HISTORIC AND DESIGN REVIEW COMMISSION

June 05, 2019

HDRC CASE NO: 2019-260
ADDRESS: 107 N FLORES ST
LEGAL DESCRIPTION: NCB 122 BLK LOT 1 & 2
ZONING: D, H, RIO-7B
CITY COUNCIL DIST.: 1
DISTRICT: Main/Military Plaza Historic District
APPLICANT: David Hannan/Fisher Heck Architects
OWNER: All Out of Bubblegum LP
TYPE OF WORK: Storefront system replacement, window replacement, rehabilitation
APPLICATION RECEIVED: April 30, 2019
60-DAY REVIEW: June 29, 2019
CASE MANAGER: Edward Hall
REQUEST:

1 EAST EXTERIOR ELEVATION
3/16" = 1'-0"

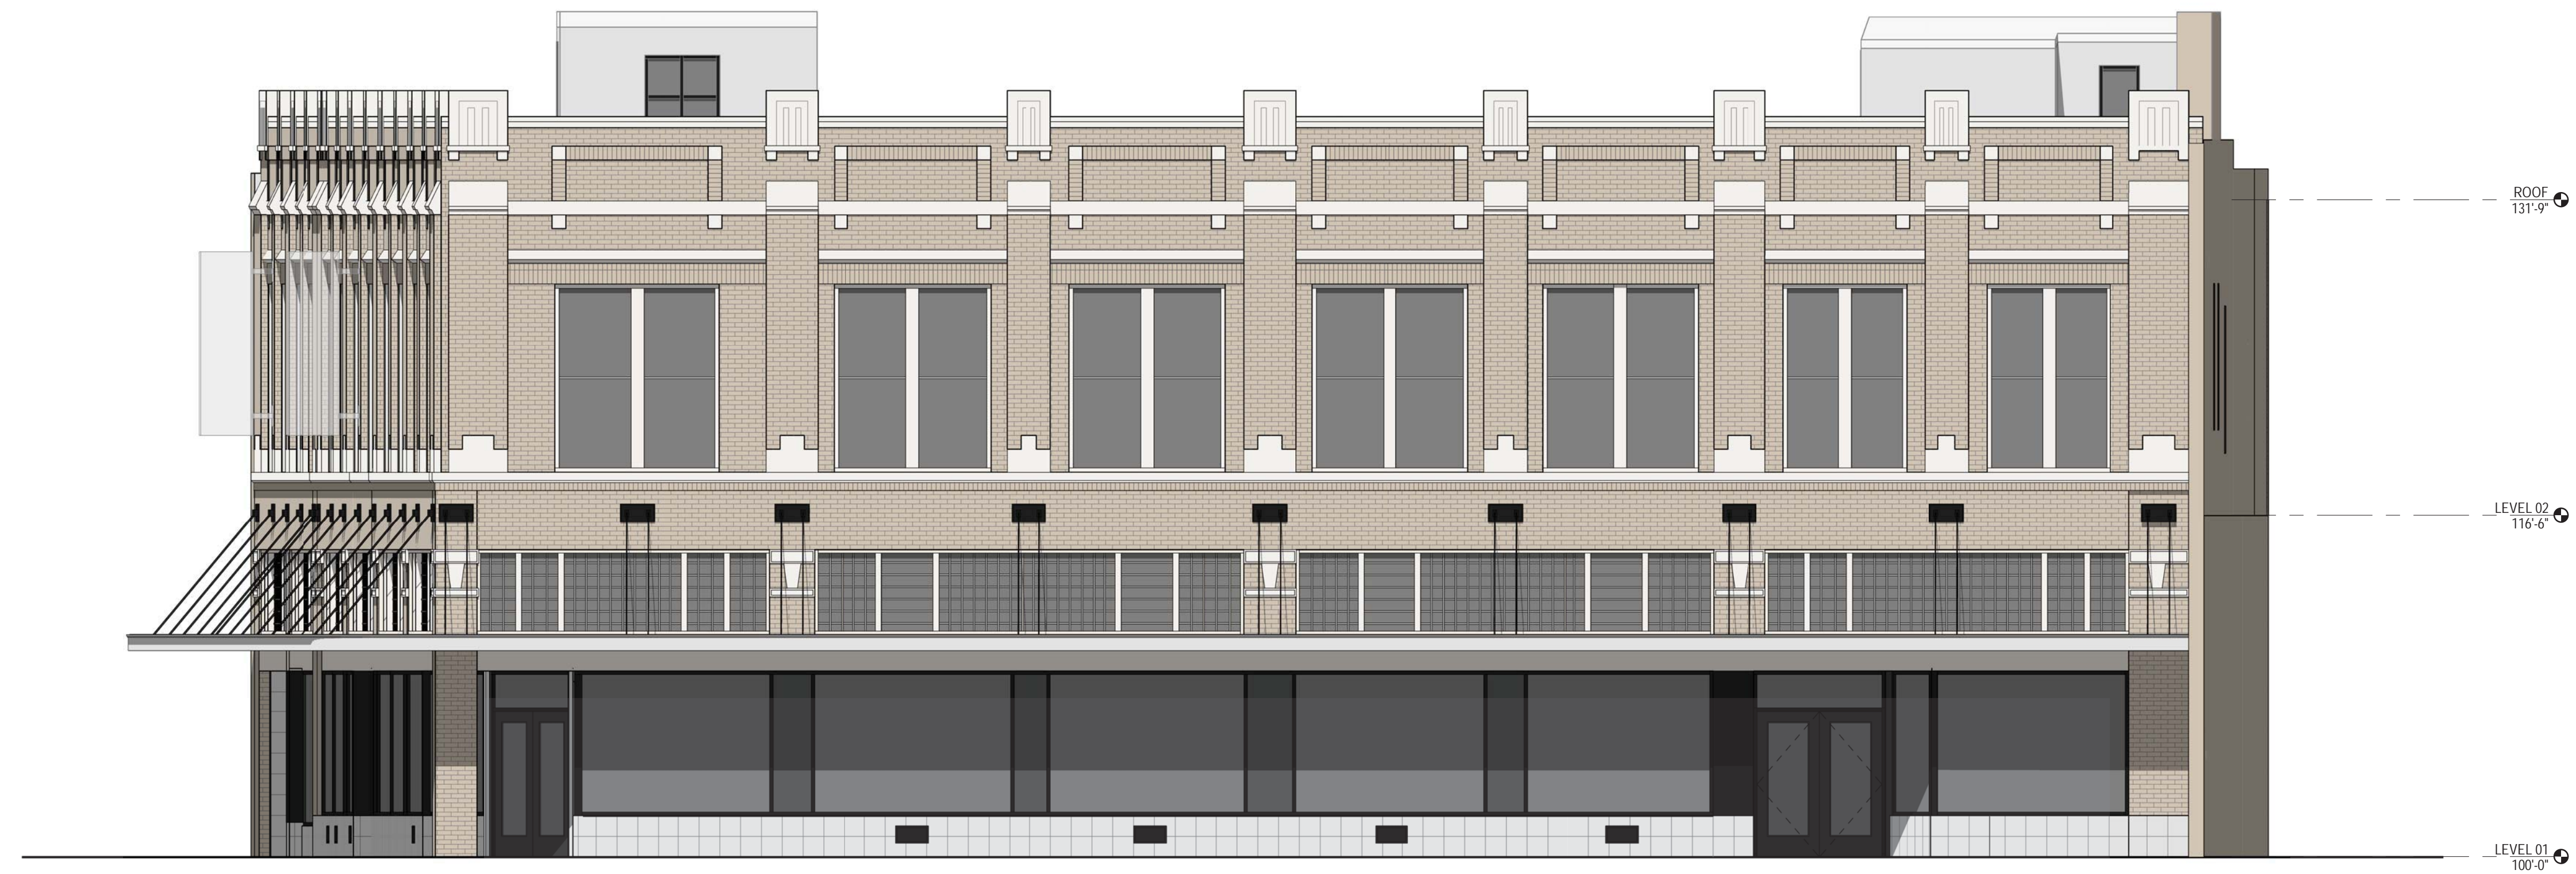
- d. **TRANSOM/CLERESTORY** – The historic structure originally featured transom windows above the ground level storefront which have been previously removed. At this time, the applicant has proposed to reintroduce these windows in the existing, enclosed openings. The applicant has proposed both the transom pattern and size of the

- e. **STOREFRONT REPLACEMENT** – The applicant has proposed to replace the existing, non-original storefront system with a new aluminum storefront system. The existing storefront system consists of aluminum frames and mullions. The applicant has proposed to install a new storefront system to feature wider, aluminum framed windows with smaller mullion profiles to match as closely as possible to those shown in historic photos, in regards to profile. Staff finds the reintroduction of storefront windows where openings have been previously enclosed to be appropriate. Additionally, staff finds the profile and window width as well as the reintroduction of spandrel panels on at column locations to be appropriate.

Staff recommends approval of items #1 through #4 based on findings a through e with the following stipulations:

- i. That all rehabilitative scopes of work be done in-kind with like materials.
- ii. That the existing masonry be cleaned in a manner which does not cause permanent damage.

WINDOW 01

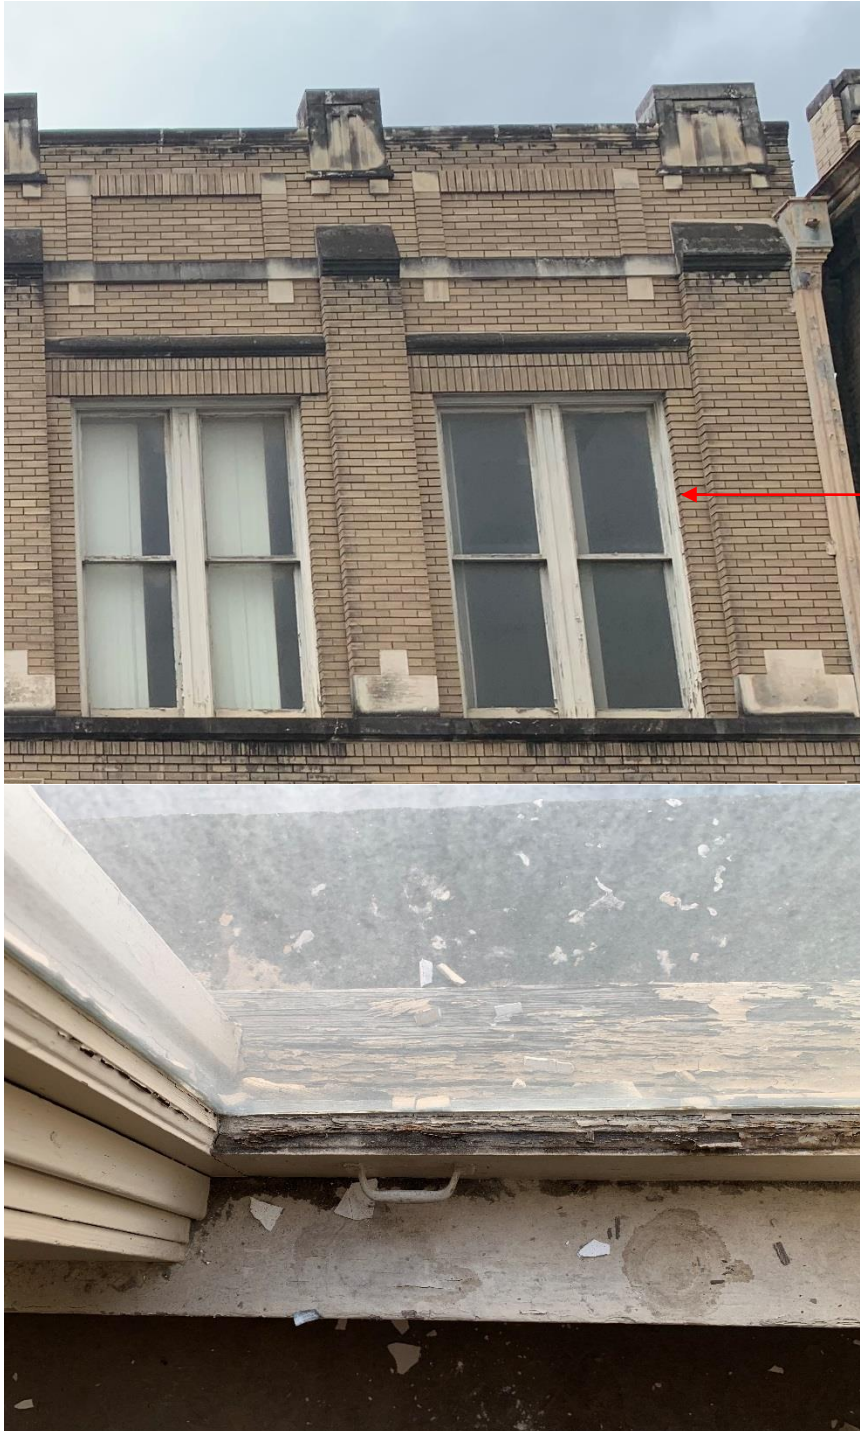
- f. **WINDOW REPLACEMENT** – The applicant has proposed to replace all of the original, wood windows on the second floor with new wood windows to feature a matching profile. The Guidelines for Exterior Maintenance and Alterations A.iii. notes that historic windows should be preserved. As noted in finding a, staff performed a site visit on March 11, 2019, where staff found that while some window sashes featured deteriorated or replacement parts, the windows were generally in repairable condition. The applicant’s proposed replacement is not consistent with the Guidelines. Staff finds that windows that are unable to be repaired, or those that are missing significant structural elements may be replaced in-kind, administratively.

Notes: Window sashes, glazing and frame are in fair condition; the lower sashes and exterior sill show signs of decay and rot from moisture exposure; Interior casing and window hardware are in good condition and will be refinished and reinstalled; Glazing putty has completely deteriorated.

Staff does not recommend approval of item #5, the replacement of the existing wood windows based on finding f. Staff finds that the window should be repaired. Windows that are unable to be repaired, or those that are missing significant structural elements may be replaced in-kind, administratively.

WINDOW 02

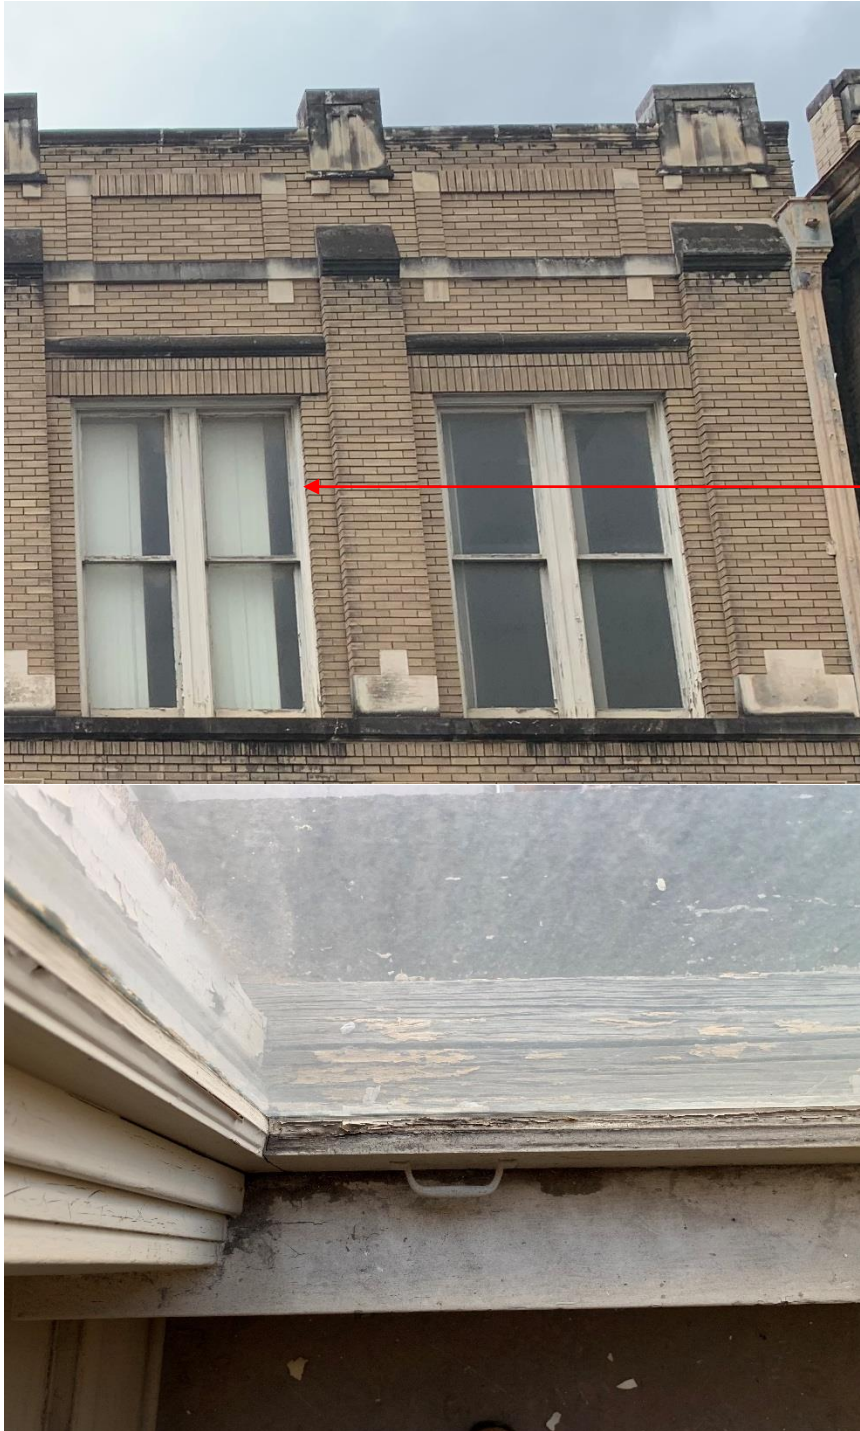
Notes: Window sashes, glazing and frame are in fair condition; the lower sashes and exterior sill show signs of decay and rot from moisture exposure; Interior casing and window hardware are in good condition and will be refinished and reinstalled; Glazing putty has completely deteriorated.

WINDOW 05

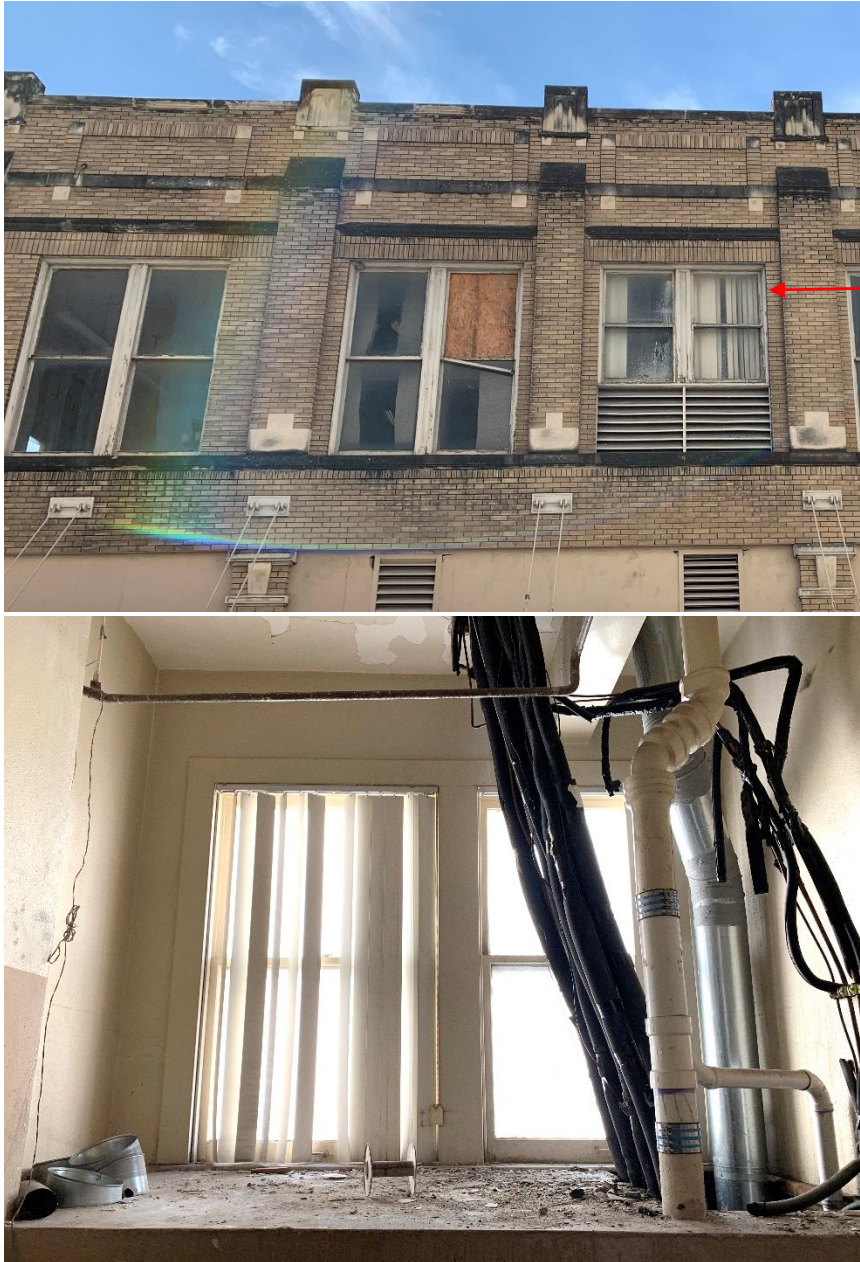
Notes: Window sashes, glazing and frame are in poor condition; the window has been heavily modified to accommodate a louver grille below, which is no longer required; the lower sashes and exterior sill show signs of decay and rot from moisture exposure; Interior & exterior casings would have to be replaced; Glazing putty has completely deteriorated.

WINDOW 16

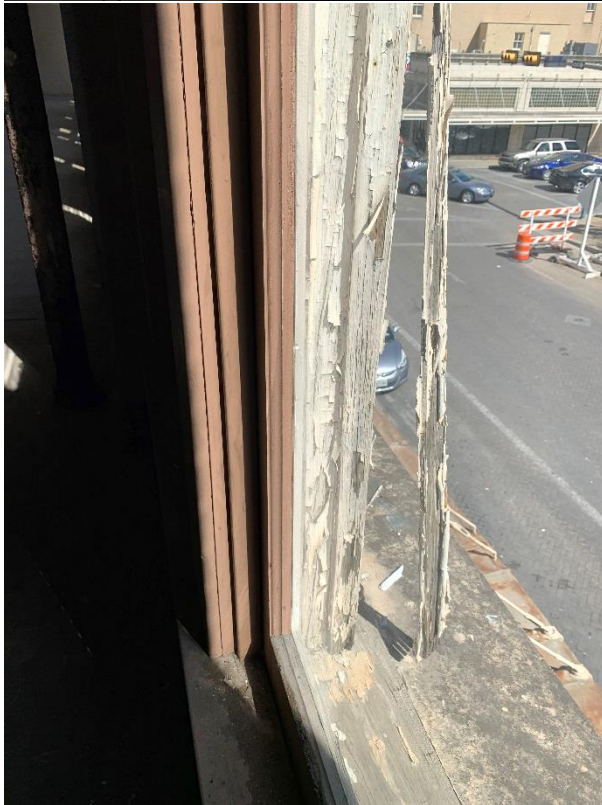
Notes: Window sashes, glazing and frame are in poor condition; the lower sashes and exterior sill show signs of decay and rot from moisture exposure; One of the glass panels and sash have been removed and replaced with plywood; Interior casing and hardware are in good condition and will be refinished and reinstalled; Glazing putty has completely deteriorated.
